GRAND COUNTY Planning Commission

May 11, 2016
6:00 P.M. Regular Meeting
Grand County Courthouse
Council Chambers
125 E Center, Moab, Utah

MEETING DATE: May 11, 2016
TO: Grand County Planning Commission
FROM: Planning Staff
RE: Amended Plat of Lot 18 of All American Acres

MEETING DATE: May 11, 2016
TO: Grand County Planning Commission
FROM: Community Development Department
SUBJECT: Site Plan review for Madeline Cottages in the HC zone district

AMENDED PLAT OF LOT 18 OF ALL AMERICAN ACRES SUBDIVISION
IN SECTION 26,
TOWNSHIP 26 SOUTH, RANGE 22 EAST,
SALT LAKE BASE AND MERIDIAN

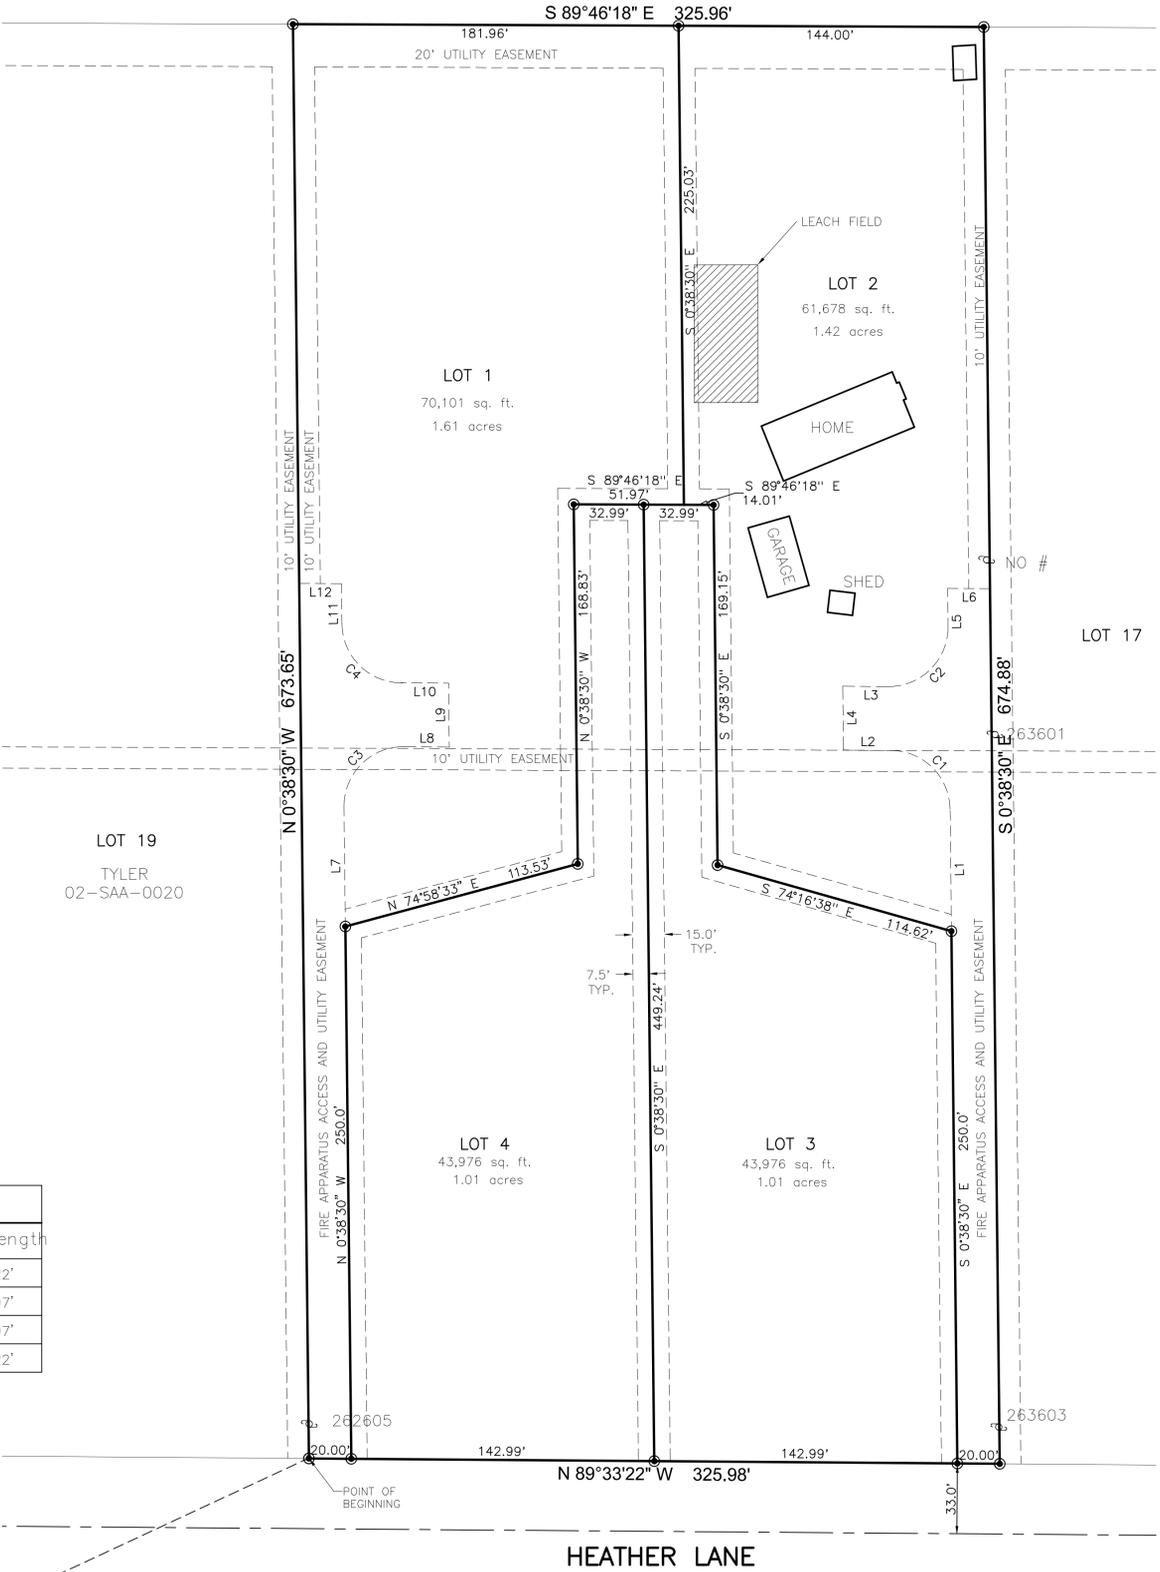
1. County Engineer's approval of the drainage waiver.

Finding = Proposed Lots meet the dimensional requirements of the RR zone district for single-family housing / 1 acre minimum lot area. Lot 1 and 2 are flag lots and shall meet the following requirements: (1) has 20 ft. of frontage on a dedicated public street, (2) the "handle" portion of the lot is at least 20 ft. in width and not more than 250 ft. in length, and (3) the body of the lot meets the lot area and lot width requirements of the underlying RR zone. The plat will reflect compliance.

Finding = The County Engineer has been provided the drainage plan and we are waiting on his report. necessary.

Staff recommends approval of the minor subdivision and Plat Amendment of Lot 18 of All American Acres with conditions that the County Engineer approve the drainage waiver.

C2.0
 IMPROVEMENT PLAN

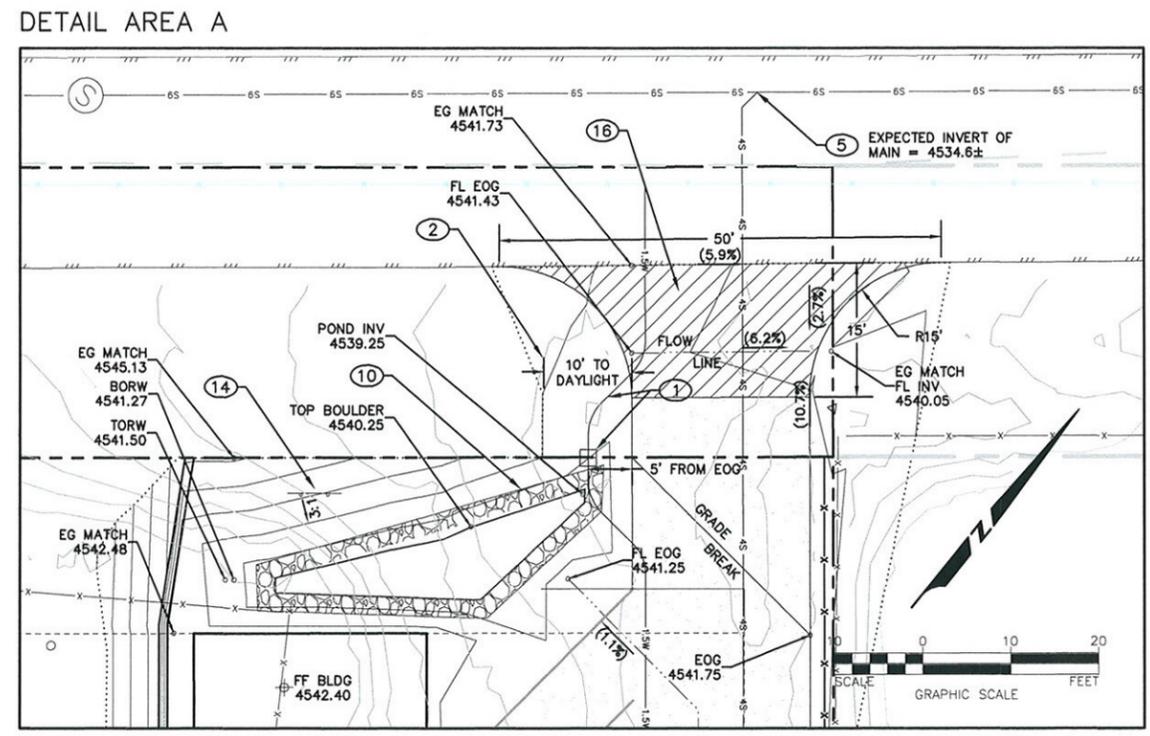
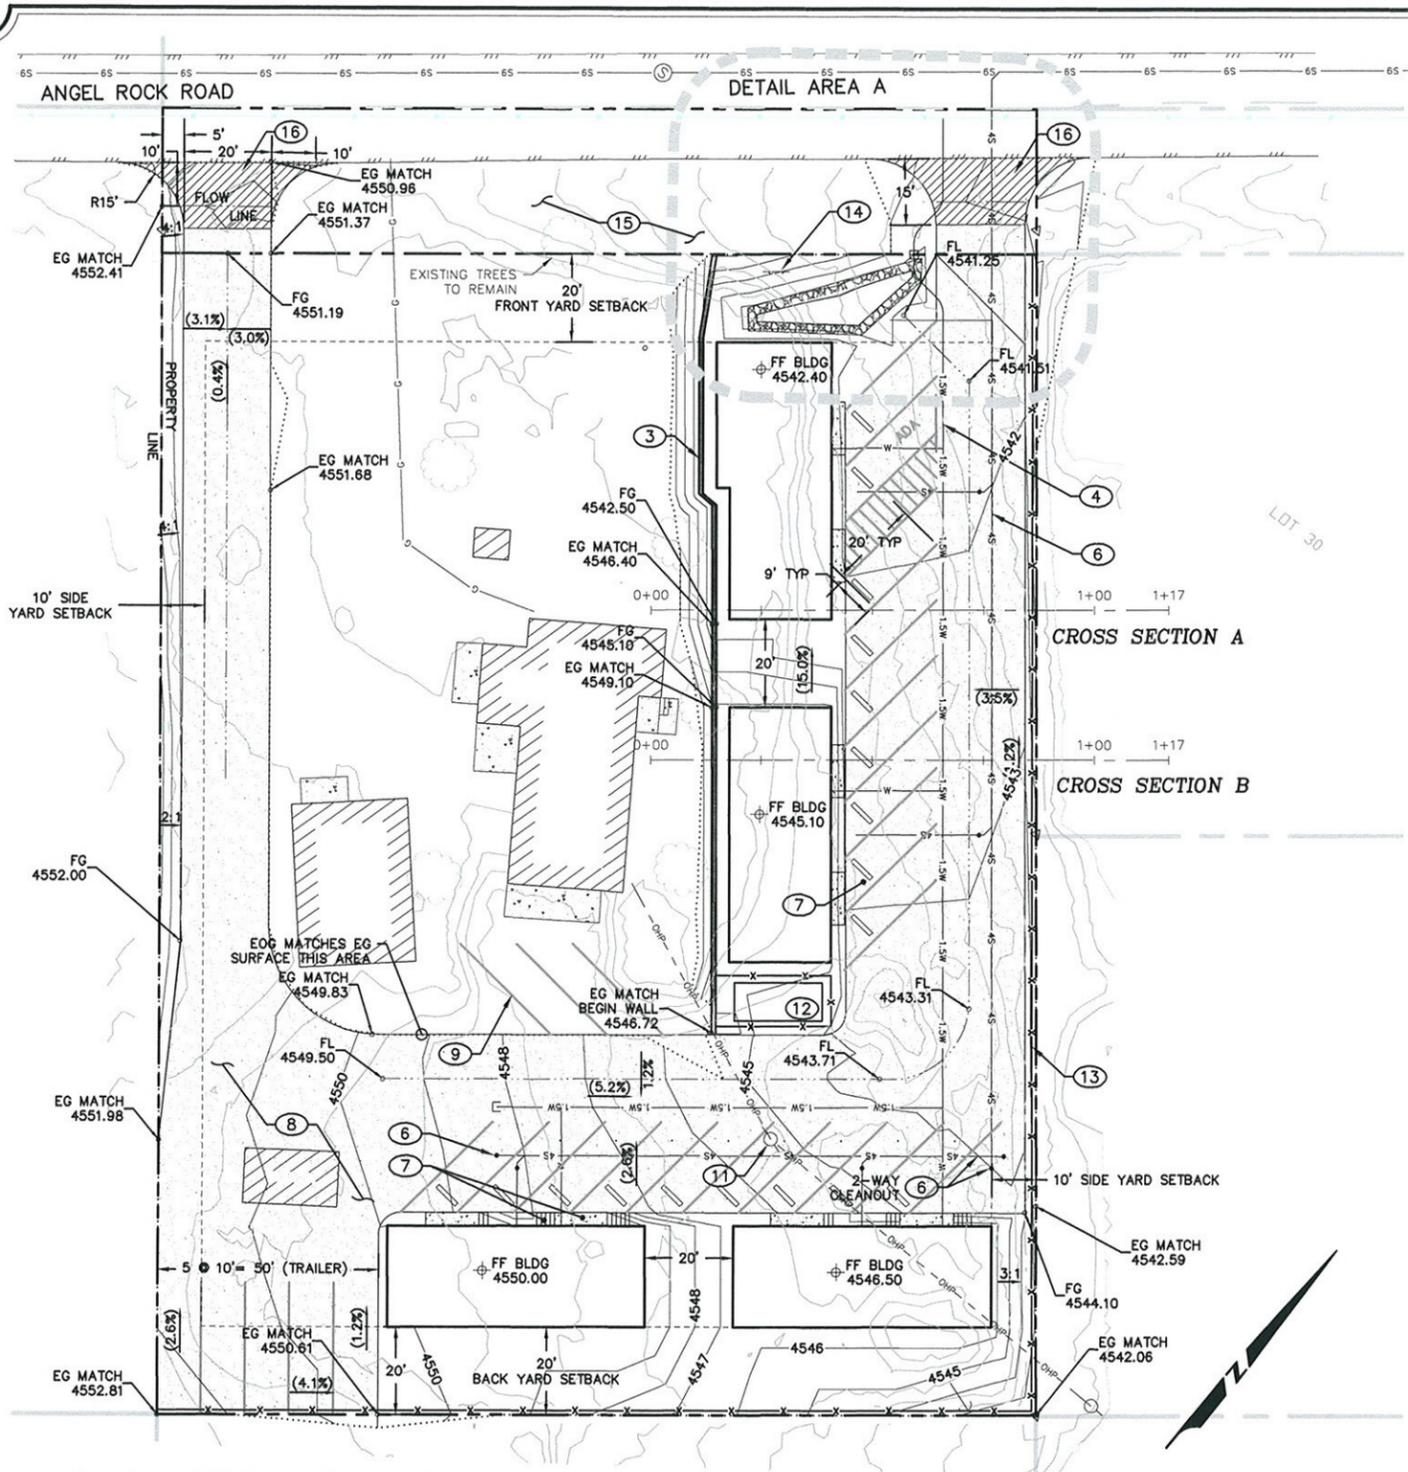
1. **Drainage Plan.** The County Engineer shall approve, in writing, the storm water drainage plan prior to building permit.
2. **Parking.** Move parking spaces out of the required front setback.
3. **Landscaping.** Landscaping will need to be in and irrigated prior to a Certificate of Occupancy.
4. **Lighting.** Lighting cut sheets will need to be provided at building permit.

- A. **Sec. 6.1.7 Parking**, each parking space shall be set back at least 15 feet beyond the front yard setback. Each space shall be 9 feet wide 20 feet long. *Parking needs are in compliance, there are parking spaces within the required setback.*

- E. **Sec. 6.10 1.E. Compatibility – buffer and screening** – LUC requires the plan to include a six (6) foot opaque screening adjacent to the residential zone or a lot with a residence or duplex use. *Site Plan illustrates a six foot high opaque fence on the east and southern parcel boundary. There is a single family home on the southwest boundary.*

- F. **Landscaping and screening** – Section 6.4 Landscaping and Screening – the LUC requires a front landscaping feature, landscaped as follows; *A landscaped strip is assumed in the front setback, but will need to be illustrated on the site plan.*

- G. **Locations and dimensions of structures and signs** - signage is subject to the requirements of Sec. 6.5. *Signage is proposed. Plan illustrates a 4X6 monument sign at the front entrance.*

- H. **Outdoor lighting** – lights shall meet the requirement of Sec. 6.6. *A lighting cut sheet will need to be provided and shall meet the requirement of the sec. 6.6 of the LUC.*

- I. **Drainage and floodplain** – Sec. 6.7 a drainage plan will be required in order to mitigate drainage if proposing more than 7,000 square foot of impervious area, or a natural drainage way is altered. *A drainage plan has been provided and sent to the contract engineer for review.*

- Please provide in the narrative the purposed uses of structures on the site plan, and
- electronic copies of the plans,
- Set-back of parking shall to demonstrated on the site plan,
- If new lighting is proposes cut sheets shall be provided,
- Check with the Building Code for required ADA parking spaces,
- Landscaping details shall be required, see requirements above,
- Engineering for the drainage has been sent to the County Engineer.
